**Response to s165 Conditions of Notice of Decisions for Application ID: 201936510**

**Project Name: Proposed Asphalt Plant, Hume – Independent Expert Review 2**  
**Reference: 21.1004.L1V1**

<b>Project Name:</b>	<b>Proposed Asphalt Plant, Hume – Independent Expert Review</b>
<b>Reference:</b>	<b>21.1004.FR1V1</b>

**Proposed Asphalt Plant, HUME  
5 Paspaley Street (Block 67 Section 22)**

Figure 1 Air Extraction and Ducting System for Dust/Odour Emissions Control

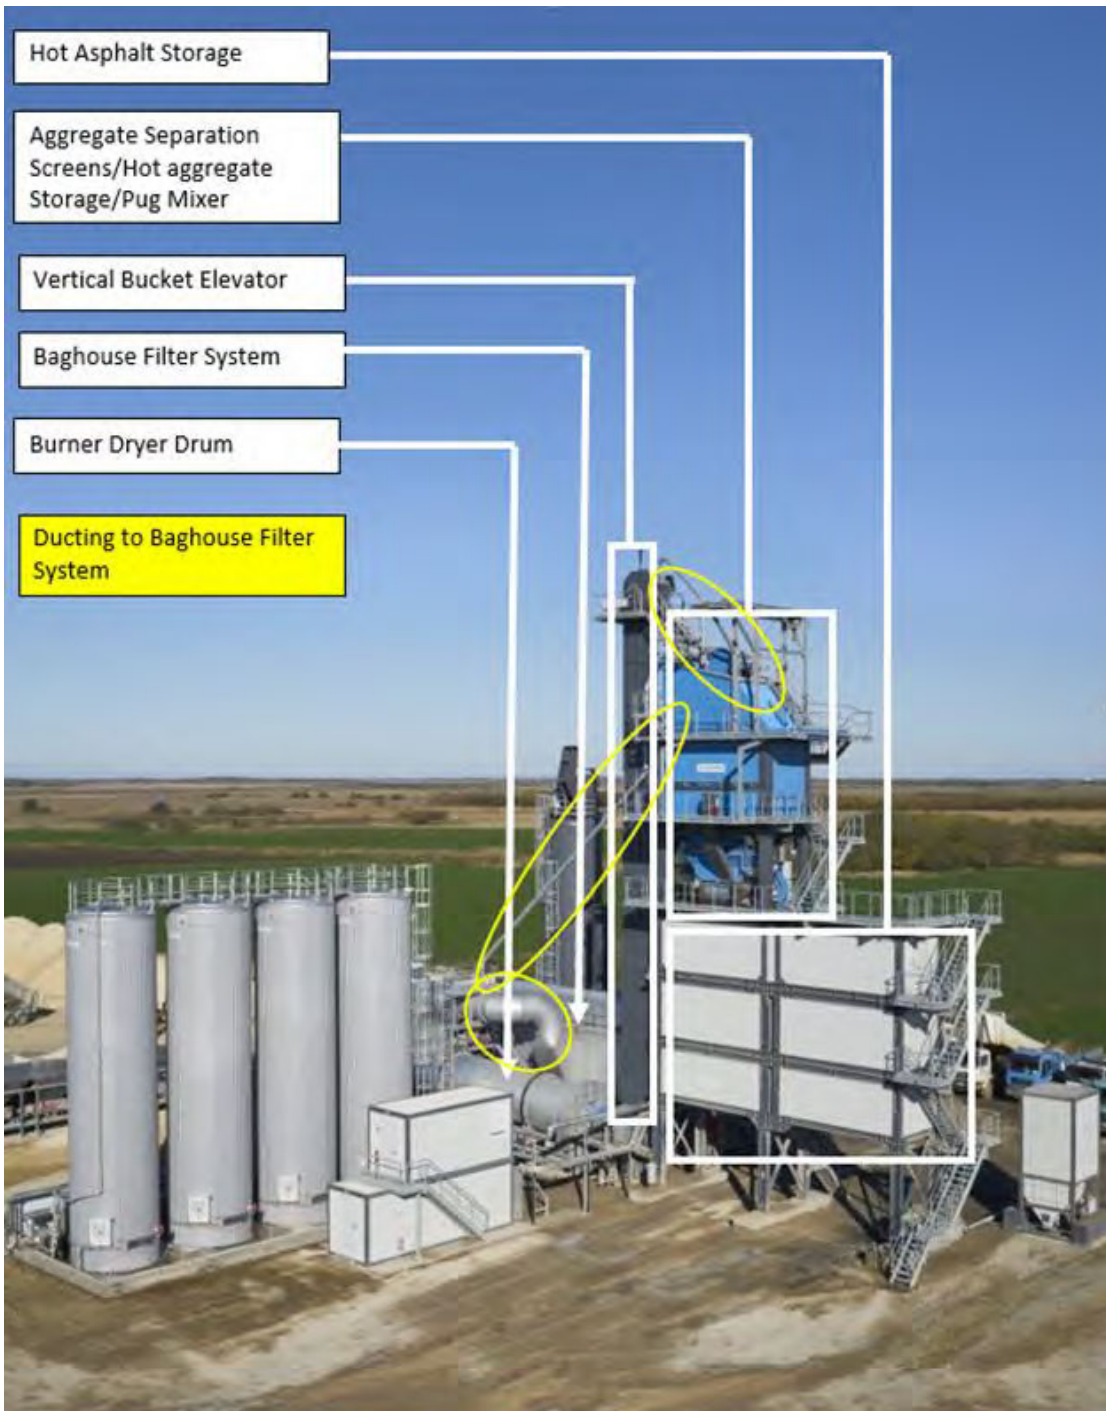
*Additional information is recommended to be provided which describes in detail the operation of the proposed plant, and where emissions of odour may be anticipated. Importantly, where no emissions are anticipated, the reasons for this should be fully discussed in terms of the materials being handled, best practice control measures to be implemented, and/or the contingencies in place should any failures in those measures eventuate.*

The pugmill and hot mix silos in Benninghoven plants are fully enclosed and through the design of the plant are subject to negative pressure to ensure that no dust or vapours escape. This vacuum is maintained by the filtration system through a series of ducts and is a factory standard inclusion in Benninghoven plants. If there are any light ends (bitumen vapours) emitted from the hot mix within the hot mix bins, they must travel through a controlled dense build-up of dust attracted to the filtration fibre (known as 'filter cake') where they become trapped. The captured dust is pulsed (bags shaken) into the reclaimed dust cycles for reuse within the process.

In summary, the proposed plant will be an enclosed process with the emissions captured in the baghouse and residual emissions released through the dryer stack as assessed in SLR Report. If the filtration system or baghouse is inoperable for any reason, the plant would not operate until it is fixed.

Figure 1 shows each process component described above and shows the connection points to the baghouse Filter System.

Figure 3 Bitumen Tanks and Vapour Recovery Pipeline

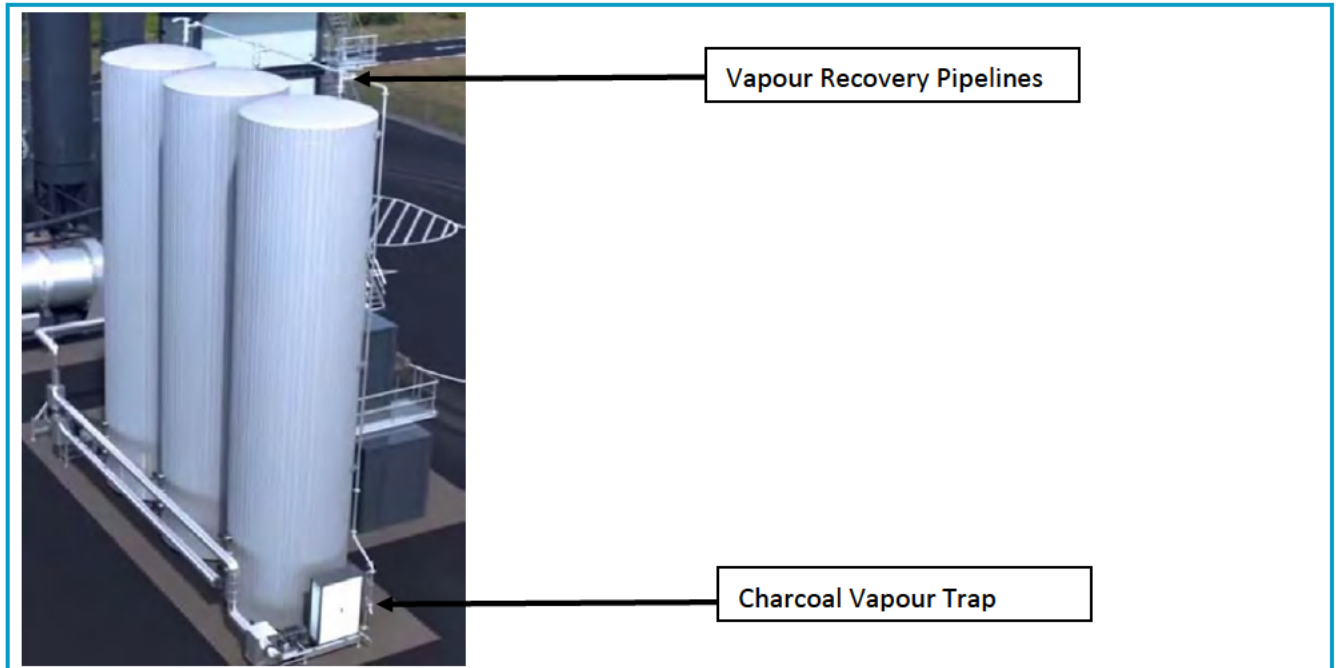
*If considered appropriate, following detailed review of the plant emissions in [1], it is recommended that emissions of odour from the bitumen tank (breathing losses) are included. It is noted that emissions of toluene from the bitumen tank have been modelled, although a corresponding odour emission has not been derived or assessed.*

Vapours/fumes from the heated bitumen tanks will be captured using a series of pipelines connecting each bitumen storage tank to a charcoal vapour trap located at ground level. This trap treats any vapours emanating from the bitumen tanks during the loading from the bitumen delivery tankers (working losses), and from maintaining the bitumen temperature during storage (breathing losses). This is illustrated in **Figure 3**.

**Figure 4 Contour Plots showing 2 ou Contours (99.9<sup>th</sup> percentile)**

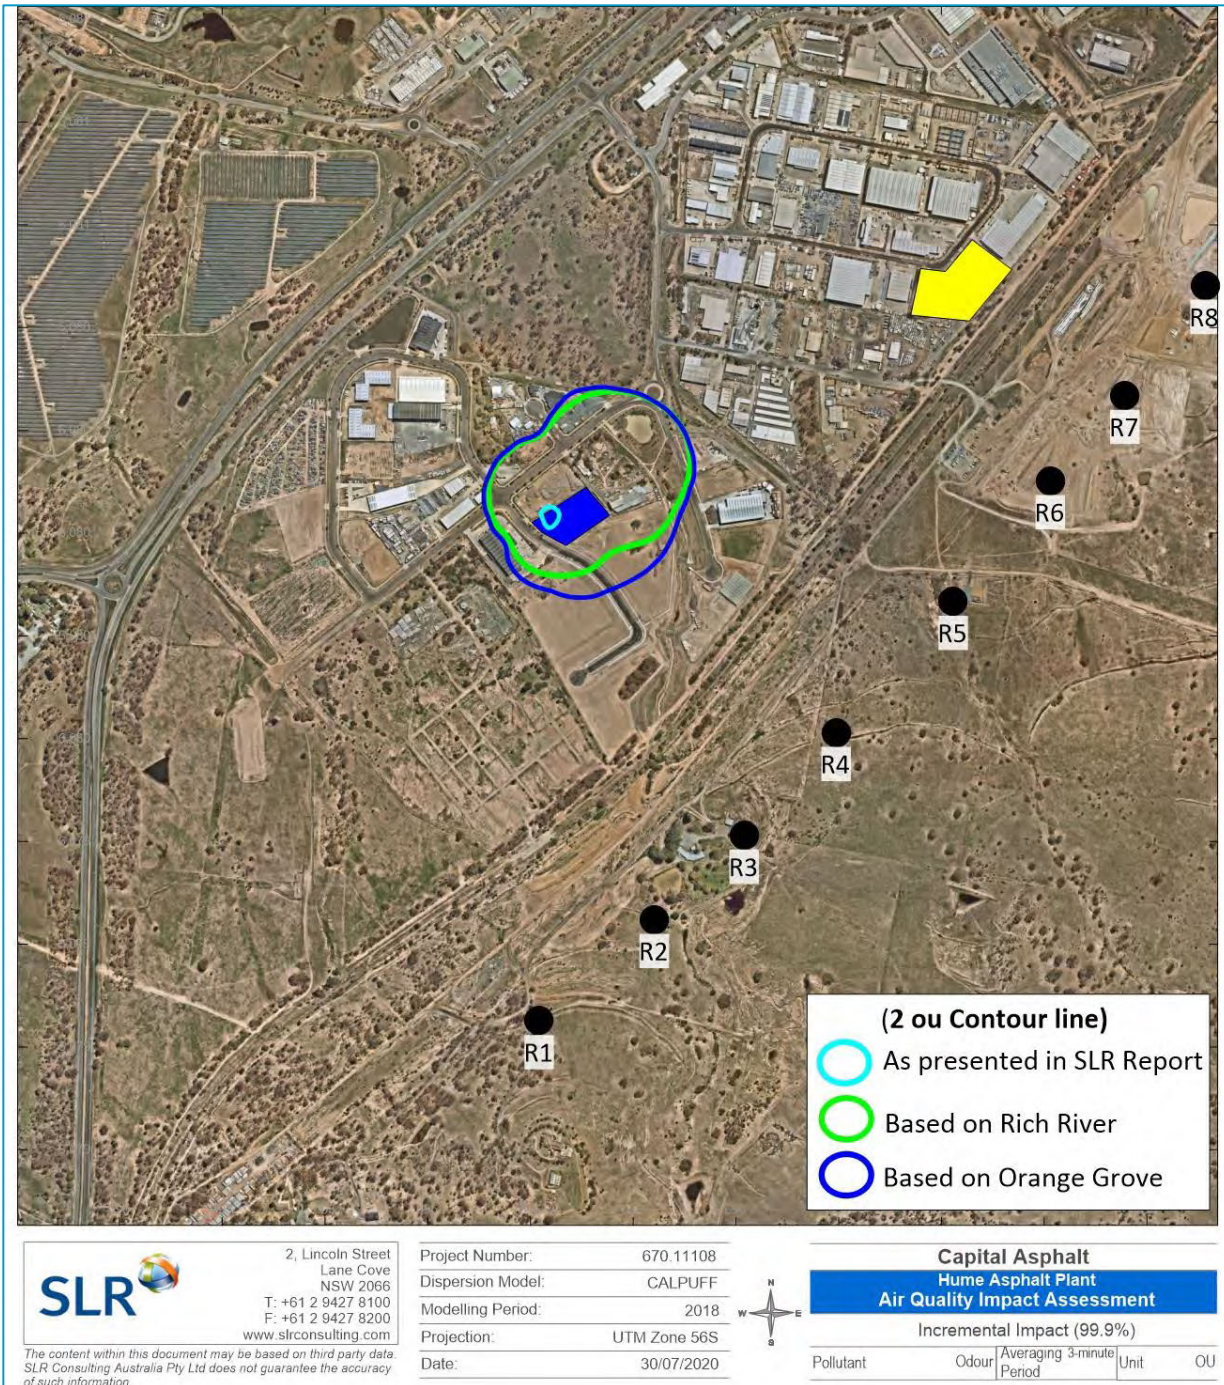
*Based on the outcomes of issues 1 to 4, it is recommended that the cumulative assessment should be re-performed. In addition, it is suggested that Council be approached to assess whether the supporting documentation for the Downer plant might be released, and whether any odour complaints data might be available to allow 'ground-truthing' of any modelling assessment.*

The odour impacts predicted using emission rates adopted from the Rich River and Orange Grove asphalt plants are presented in Table 2 and Table 3 respectively. It is noted that the cumulative predictions do not necessarily match the sum of the Project impacts plus Downer EDI impacts because the maximum predicted impacts from the Project and the Downer EDI plant may not occur on the same hour.

The respective odour contour plots are shown in Figure 3. A larger impact area within 2 ou (Project odour criterion) is predicted when emissions are adopted from Orange Grove or Rich River asphalt plants. However, no significant difference is noted between the Orange Grove or Rich River asphalt plants impacts despite a large difference in emissions from dryer stack (ie 30,333 ou for Orange Grove compared to 4,983 ou for Rich River). This shows that the difference in downwind impacts is attributed to the load out area which was modelled as a volume source. As mentioned above, the modelling of load out area is conservative in nature due to the proposed suction fans (see Figure 2).

In summary, the additional modelling performed using odour emission rates based on data sourced from the Rich River and Orange Grove asphalt plant, predicts a higher level off site impacts, with exceedances of the adopted odour criterion for sensitive receptors predicted to be exceed in a localised area close to the site boundary. No significant impacts from the proposed plant are predicted for neighboring residential areas.

**Figure 5 Comparison of the Observed data at Tuggeranong AWS and Canberra Airport AWS (2018)**

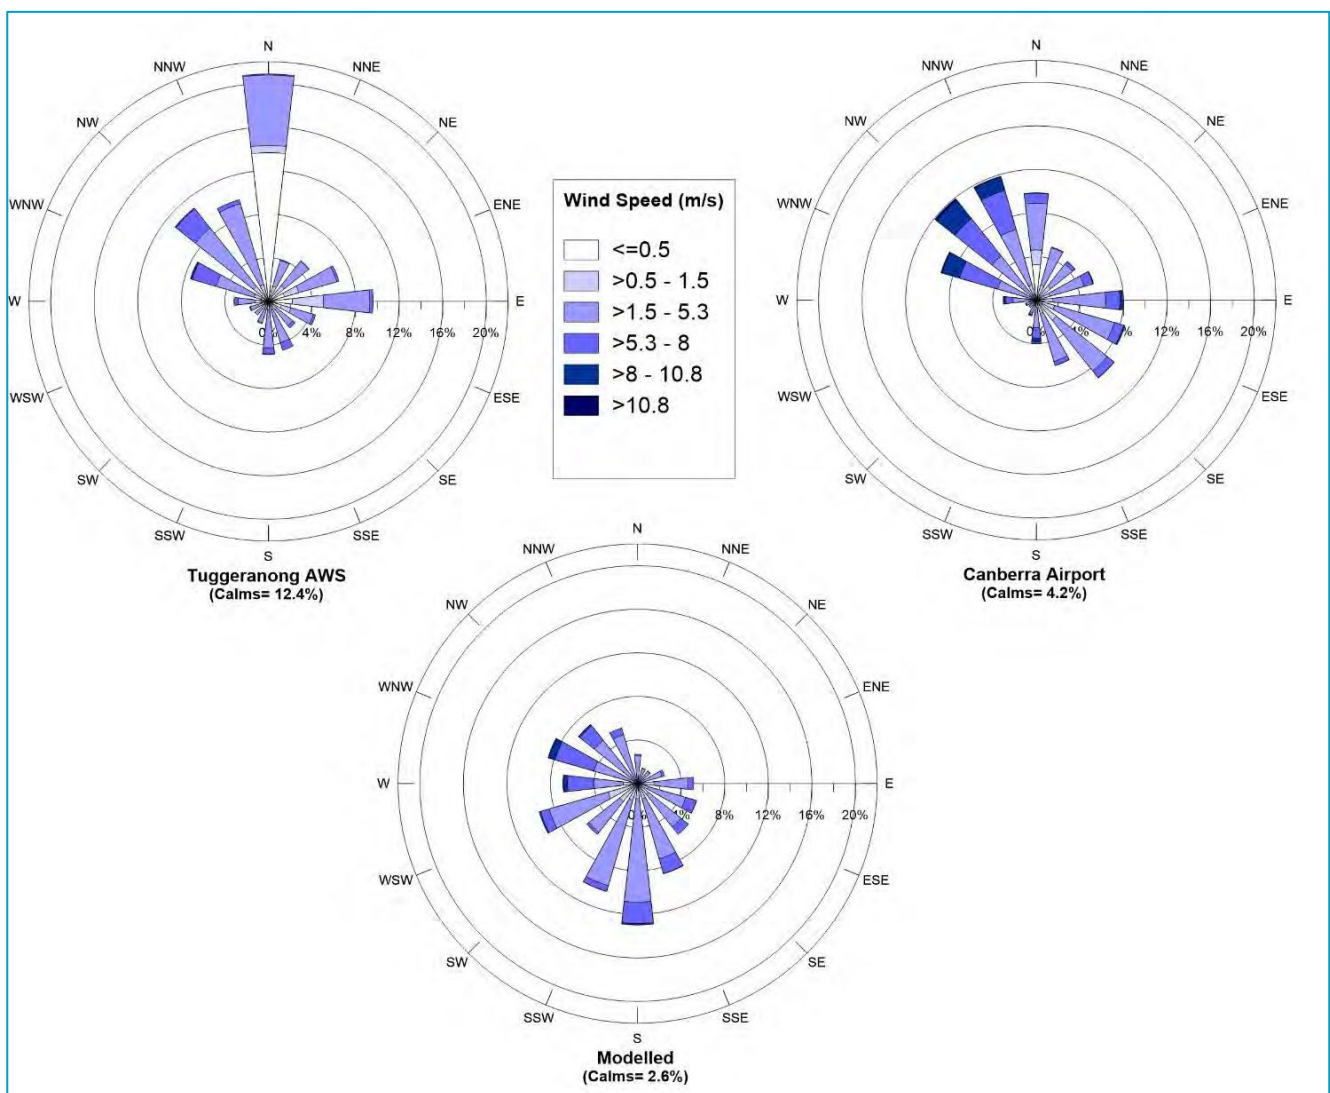
Provide a validation of the meteorological data used as input to the modelling assessment against observations.

A comparison of the wind patterns for the observed data at Tuggeranong Automatic Weather Station (AWS), Canberra Airport AWS and modelled meteorological data at the Project Site are shown in **Figure 5**.

Note: As Tuggeranong AWS was used in the modelling, it is not appropriate to extract data at Tuggeranong AWS to validate meteorological modelling.

**Figure 2-1: Odour dispersion modelling results for the 99.9<sup>th</sup> percentile 3-minute average**

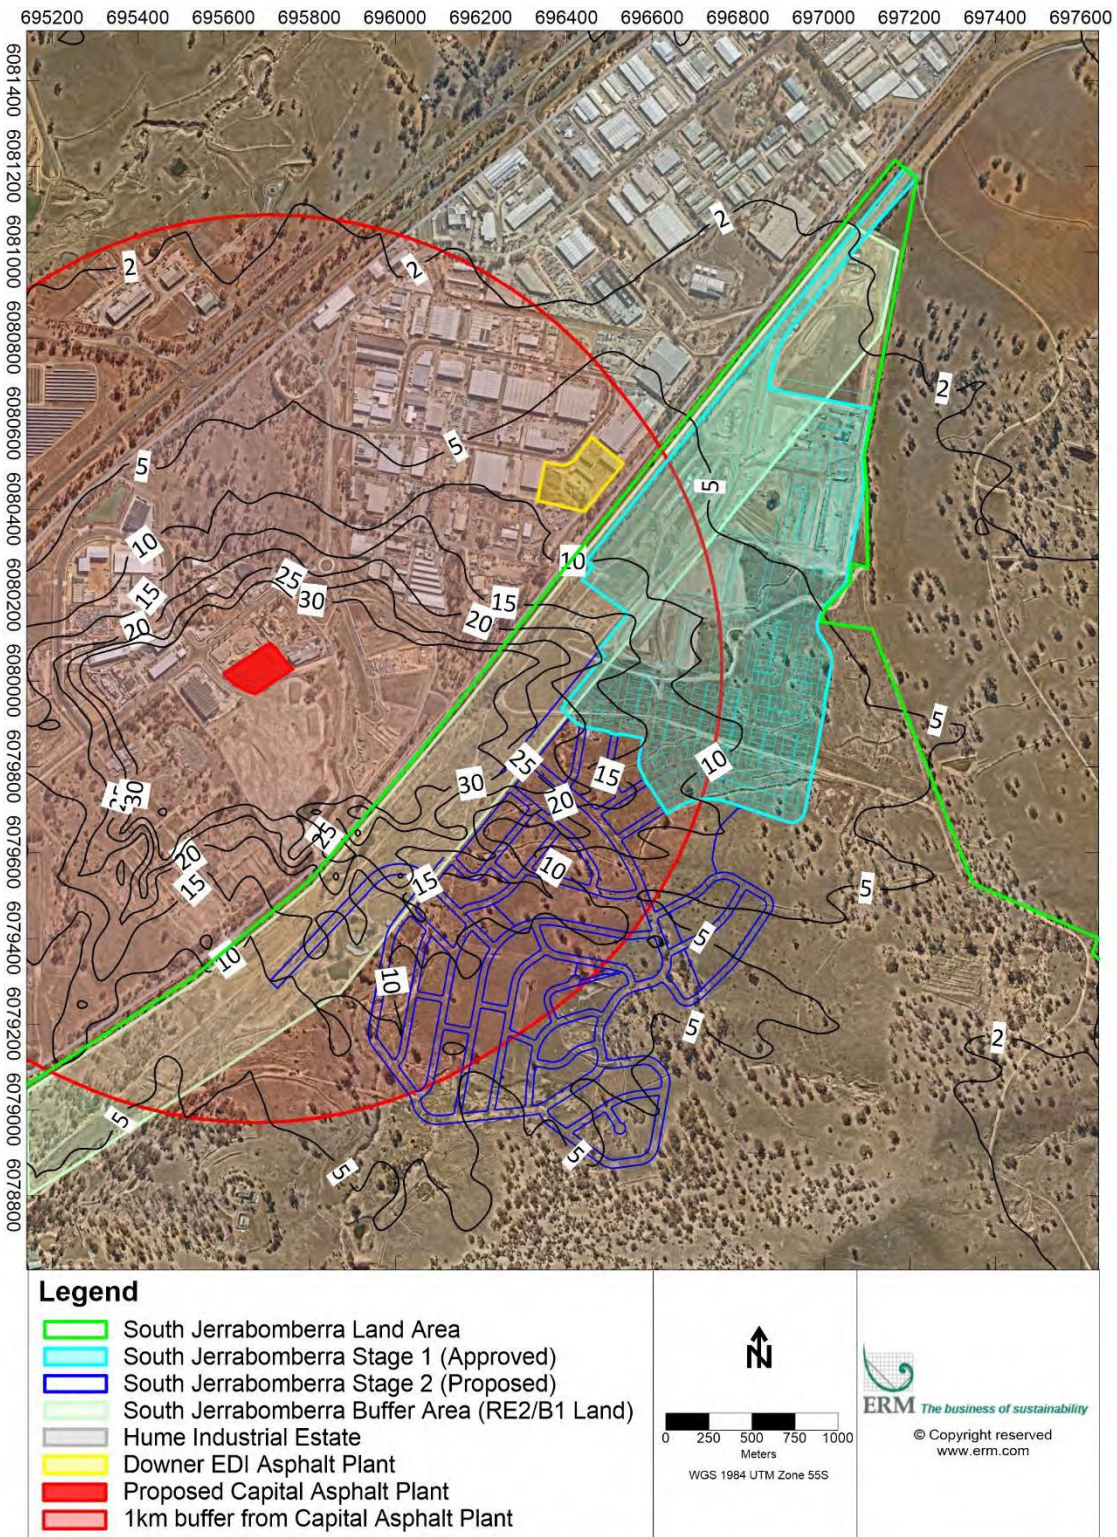
It can be seen from Figure 2-1 that maximum odour predictions are anticipated to significantly encroach upon South Jerrabomberra, with the 5 OU contour incorporating the entire residential area. Areas of significantly higher odour predictions occur closer to the plant; 10 – 20 OU at the western edges of the residential areas, and up to 30 OU occurring within the 'buffer area', all well above the recommended level of 2 OU.

**Figure 2-2: Predicted odour 99.9<sup>th</sup> percentile 3-minute average impacts from the proposed asphalt plant (SLR, 2020)**

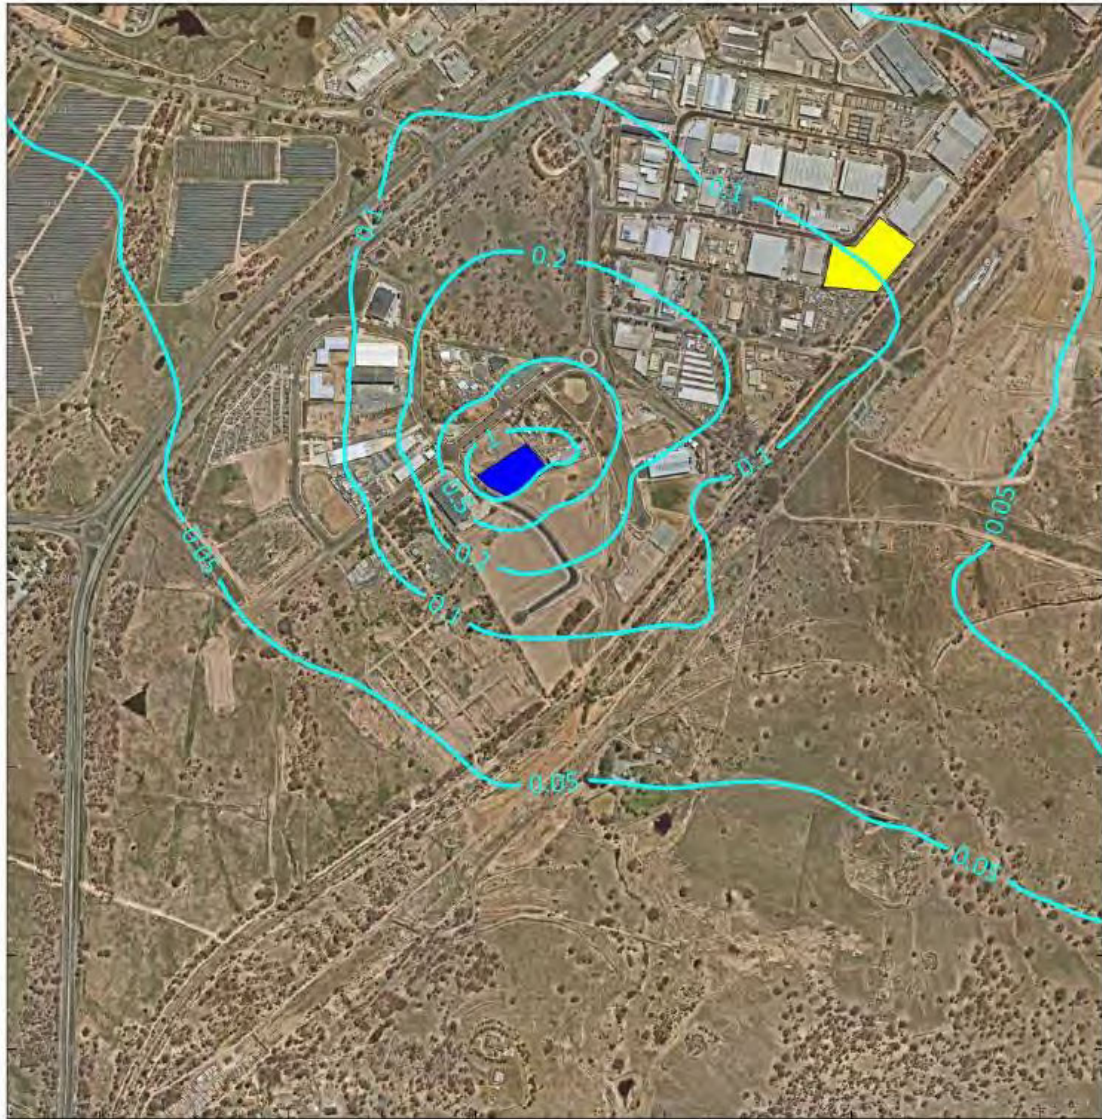
Issues 1 and 2 as they relate to the odour emission inventory for the Capital AQIA appear to result in extremely low odour predictions within the Capital AQIA.

One can see the odour predictions in the Capital AQIA (Figure 2-2) at the equivalent location are approximately 0.1 OU.
